RENESAS TECHNICAL UPDATE

Product Category	MPU/MCU		Document No.	TN-16C-A244A/E	Rev.	1.00
Title	Notes on the POR (Power-On Reset) Function and Power-On Start		Information Category	Technical Notification		
Applicable Product	M16C/65,M16C/64A,M16C/6S1 M16C/6B,M16C/6C,M16C/64C,M16C/65C M16C/63		Lot No.	Reference Document	—	
			—

Figure 1. Waveform on Power-On Start with Residual Voltage

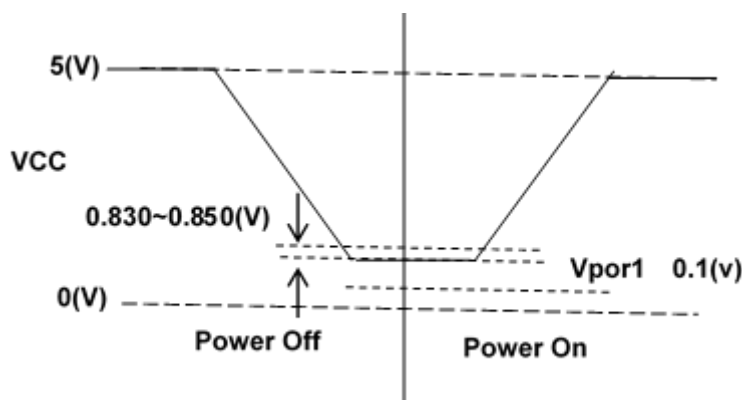
When the MCU is powered on with residual voltage (0.83 to 0.85 V),the power-on reset function may not work properly. If the hardware reset is used, this does not apply.

Note that the M16C/6S1 Group and the M16C/6B Group do not have the power-on reset function, so this does not apply to them.
